BROADWAY MAINTENANCE PROJECT CIP #42003

ADDENDUM NUMBER 1

Dated: October 10, 2023

BROADWAY MAINTENANCE
CIP# 42003
SD REHABILITATION LAYOUT
CITY OF PLACEMORE
CALIFORNIA

SHEET NO. C23 OF C36

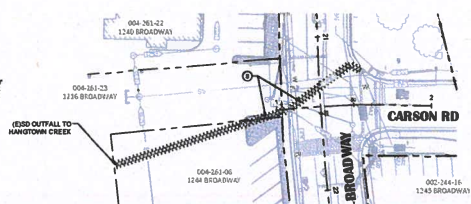
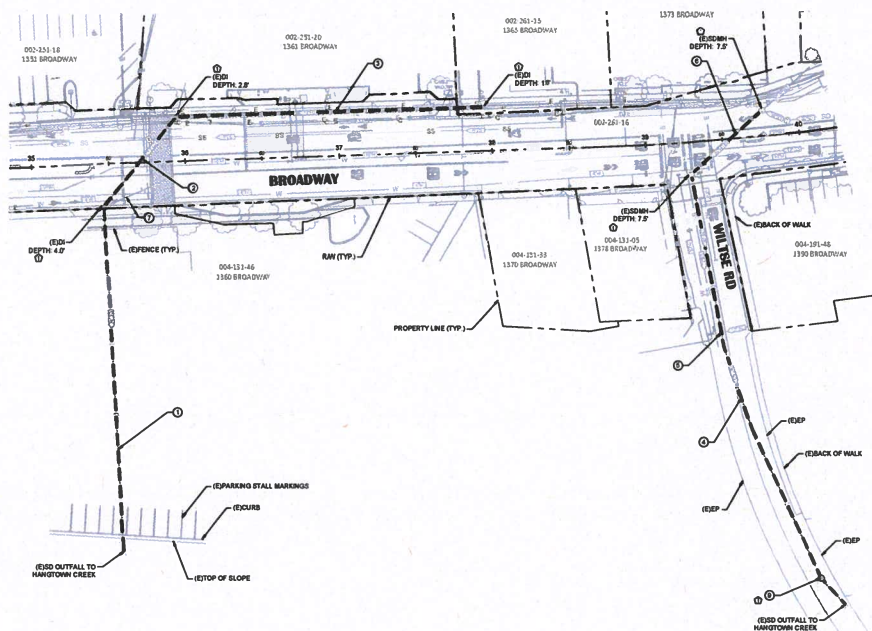
Question 2: After review of the outfall of the 36" UV CIPP Liner, it appears outfall is towards the middle of the culvert. A 36" UV liner is very heavy and has to be pulled in, due to the location of the outfall this is going to make the install extremely difficult with the weight of the liner and the bends that would need to be negotiated for install. Can a

manhole be added to the project and placed just before the bridge and the last portion of the 36" Liner be made into two segments?

Question 3: Can you provide depths of the Manholes for the UV CIPP Liner?

- Sheet C23*: Added depths to the existing storm drain manholes and inlets in the systems receiving UV Cured SD CIPP Lining. Added 60" storm drain manhole to this stretch of storm drain to facilitate installation of liner.

City's response to Question 2: A manhole has been added to the plans on revised sheet C23.

City's response to Question 3: Refer to plan sheet revisions for sheet C23, below and attached, for manhole and inlet depths.
